STATE OF NORTH CAROLINA  
DEPARTMENT OF TRANSPORTATION

December 15, 2020

Subject: Request for Modification to the Phased Section 404 Individual Permit and Section 401 Individual Water Quality Certification, Neuse River Riparian Buffer Authorization, Non-404 Jurisdictional Wetlands and Waters Permit for the Construction of the Triangle Expressway Southeast Extension from NC-55 Bypass in Apex to I-40, Wake and Johnston Counties. TIP Nos. R-2721, R-2828, and R-2829. Debit \$570 from WBS 37673.1.TA1.

**PERMIT DRAWING  
SHEET 20 OF 69**

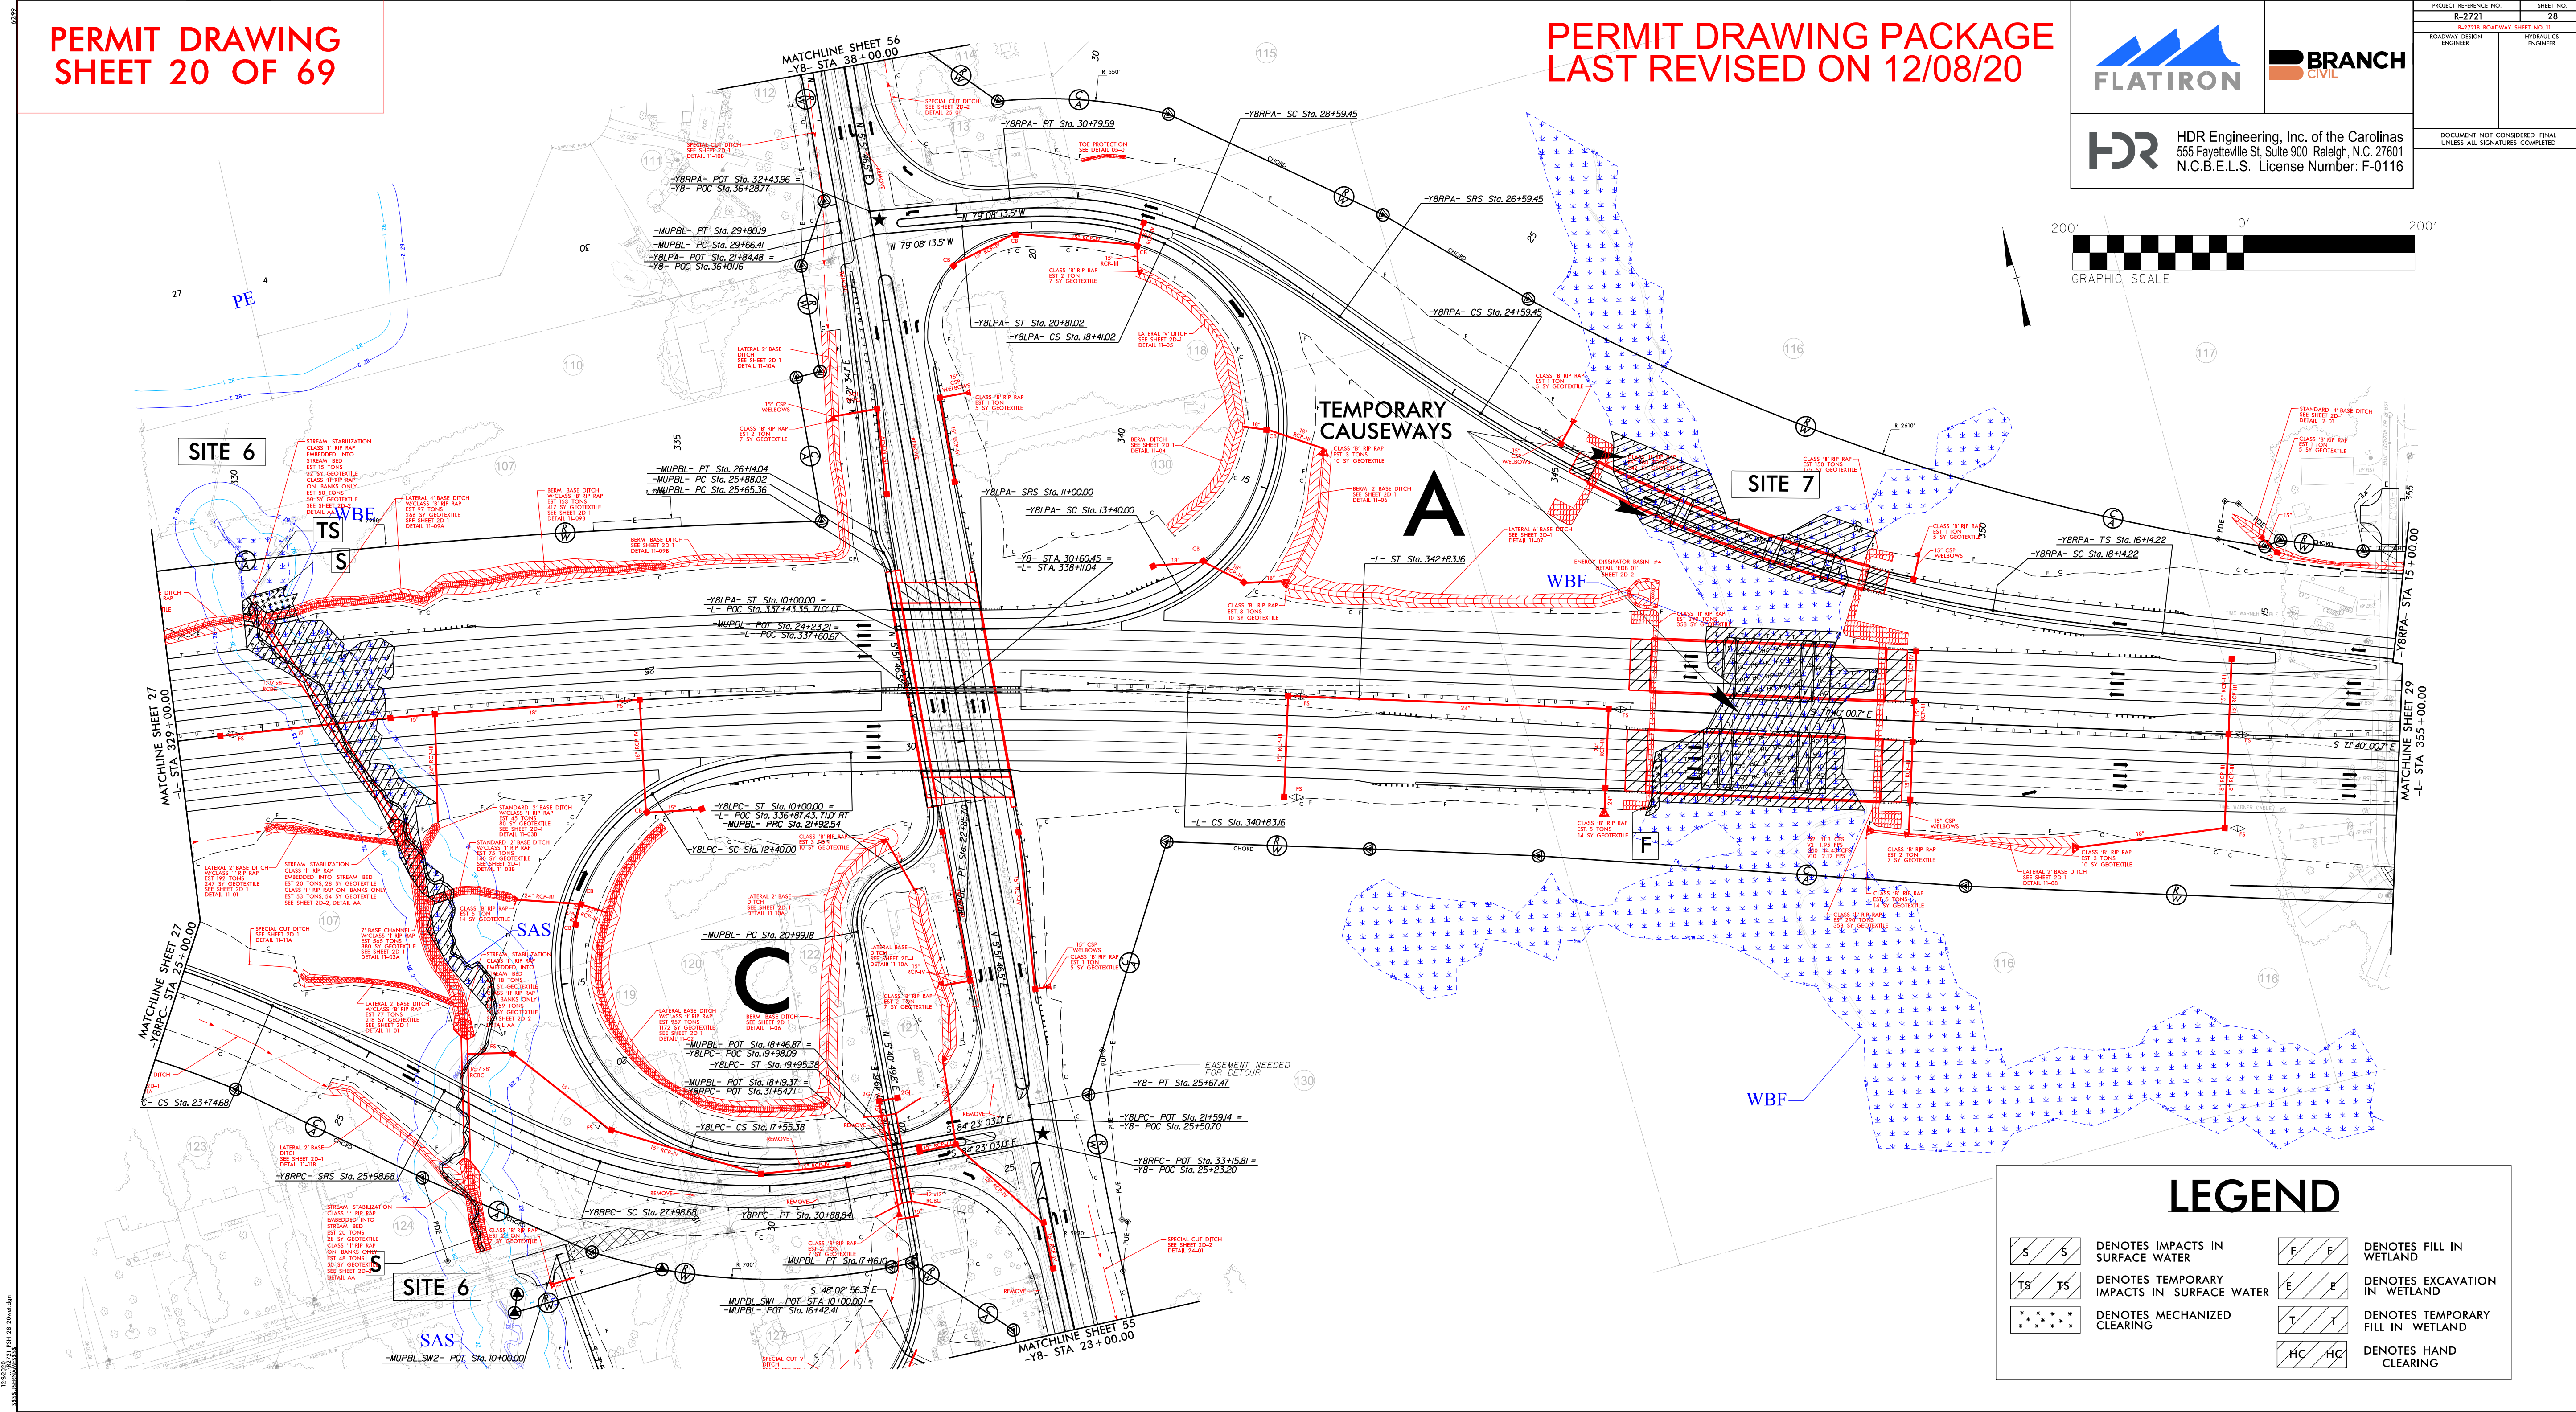
During the final design of the bridges at Permit Site 7 on the R-2721B Section, the Design-Build Team changed the span arrangement of the mainline bridge from a five span bridge to a three span bridge as well as the ramp bridge from a five span bridge to a three span bridge. By incorporating these changes there is a decrease in permanent fill impact by 0.08 acre related to the bridge bents.

Also, during this process the contractor realized that they would need to have additional temporary impacts in order to build the ramp bridge. The site does not provide enough room for them to move and place their cranes at the locations required within the currently permitted footprint. To the north side of the ramp bridge they will need an additional 0.10 acre of temporary impact beyond what was previously permitted as hand clearing. The area is now shown as temporary impact due to the need for either a causeway or crane mats. Where possible the contractor would utilize crane mats but this is likely not possible for the entire area shown as temporary impact. If a causeway or rock placement for leveling the crane mats is required, then the contractor will have geotextile fabric placed prior to rock being installed in order to maintain a barrier between the original ground and fill material. This will aid in removal of the rock.

Similar to the ramp bridge, the mainline bridge was evaluated for construction and the types of impacts have changed location. The site was previously permitted with a causeway with a number of fingers. The contractor has realized the fingers would not be necessary; however, temporary impacts would be needed at different locations to accommodate the cranes and causeway. Temporary impacts are now illustrated down the center of the alignment, to the outside of the bridge, and along the bridge abutments in order to have room for movement of the cranes. As stated above, the contractor will utilize crane mats where possible. Mechanized clearing was able to be reduced slightly. Please note that mechanized clearing is illustrated on the plans but this area would also be potentially impacted temporarily with the causeway or crane mats. It was shown as mechanized clearing due to the mitigation requirement for mechanized clearing as opposed to temporary impacts.

Due to the types of impacts changing location, there will be an increase in temporary impacts of 0.28 acre which is a change from 0.46 acre to 0.74 acre. There will be a decrease in the hand clearing impacts by 0.09 acre which is a change from 0.55 acre to 0.46 acre. There is a decrease in mechanized clearing of 0.01 acre which is a change from 0.03 acre to 0.02 acre. There is also a decrease in permanent impacts by 0.08 acre for the bridge bents which is a change from 0.20 acres to 0.12 acres of permanent fill. There is an increase in total impacts at Permit Site 7 by 0.10 acre due to temporary fill impacts replacing hand clearing, at the request of the USACE, but a decrease in overall project impacts. Please see the enclosed revised permit drawings and updated impact summary sheets which reflect the changes in impacts.
